Map No.: ADM-2023-7401-PMUL

Address: 13035 West Rose Avenue

LETTER OF CORRECTION

LETTER OF COMPLIANCE - Ministerial Review of SB 9 Urban Lot Split

TENTATIVE PARCEL MAP NO. _

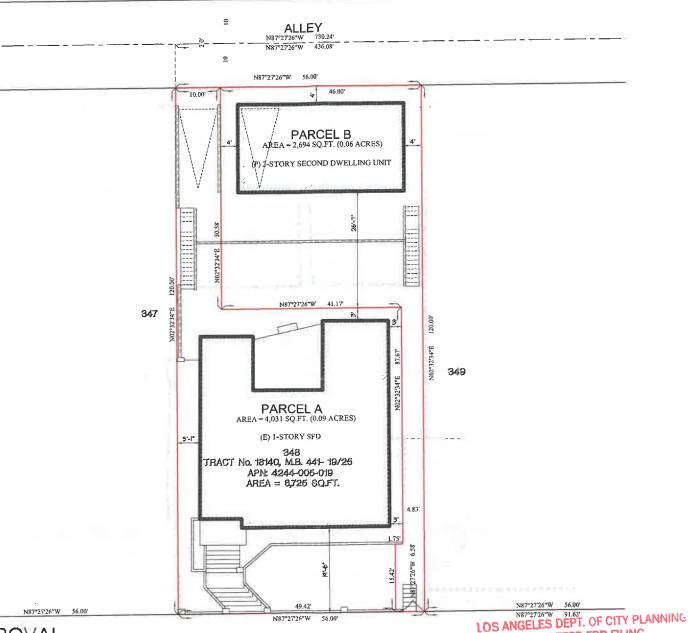
- c. The submitted plot plan is not complete. Provide a plot plan drawn to scale that accurately dimensions all building sizes on the site. Indicate the building height, floor area, and the type of construction for all buildings on the site.

- d. Revise dimension for the proposed property line along the East direction.

- e. Provide a minimum 20 ft street frontage and 20 ft wide access strip for the proposed Parcel B or obtain the approval from the Advisory Agency to approve the deviations from the Zoning Code.

- f. Provide a minimum lot width of 50 feet for the proposed Parcel B. Revise the map or obtain approval from the Advisory Agency to approve the deviations from the Zoning Code.

- 1. The proposed Parcel A and Parcel B are permitted to deviate from the minimum lot width (50 feet) requirements of the R1V2 Zone pursuant to LAMC 12.08 C.4.

- 2. The proposed Parcel B is permitted to deviate from the required 20 feet of street frontage and access strip as required pursuant to the definition of a lot in LAMC 12.03 and the 10-foot passageway requirements as required pursuant to LAMC 12.21 C.2(b).
